4. TITLE (and Subtitle) Phase I Inspection Report National Dam Safety Program BEAR CREEK RESERVOIR DAM WISE COUNTY, VA		5. TYPE OF REPORT & PERIOD COVERED 9 Final Rpts

Name of Dam: Bear Creek Reservoir Dam
State: Virginia
County: Wise
USGS Quad Sheet: Wise
Coordinates: Lat 36° 58.1' Long 82° 32.0'
Stream: Bear Creek
Date of Inspection: December 11, 1979

PHASE I INSPECTION REPORT
NATIONAL DAM SAFETY PROGRAM
BEAR CREEK RESERVOIR DAM
VA. NO. 19511

SUBJECT FIELD SKETCH
BEAR CREEK RESERVOIR DAM

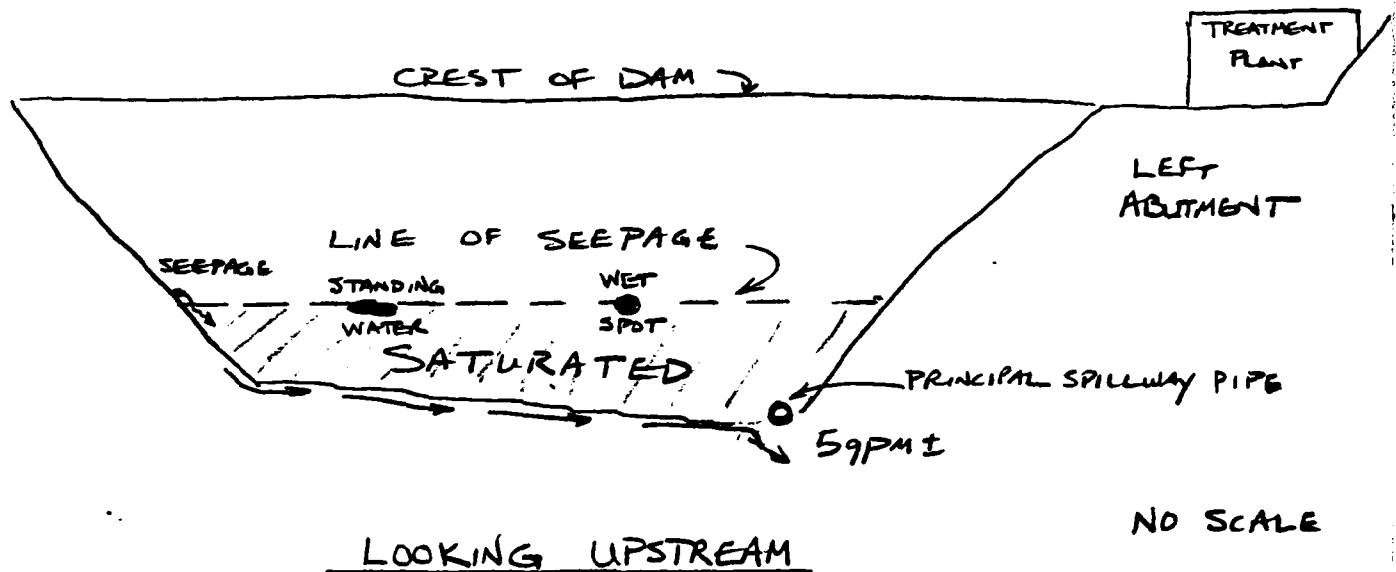
SEEPAGE - $\frac{2}{3}$ WAY DOWN ON RIGHT ABUTMENT - DAM CONTACT
STANDING WATER - $\frac{2}{3}$ WAY DOWN - IRON STAINED SEEPAGE
WET SPOT - $\frac{2}{3}$ WAY DOWN - SMALL ZONE OF SEEPAGE WITH
SWAMP GRASS. NO FLOW BUT SPONGY.

7.3.1 Seepage present along the downstream slope is of concern since it appears to indicate widespread seepage through the dam. The downstream slope should be monitored quarterly and after high pool levels in the reservoir to detect any increase in flow rates which may cause piping within the embankment. If increased flow rates should occur, a professional Geotechnical Engineer should be contacted to evaluate the problem and make recommendations for required corrective measures.
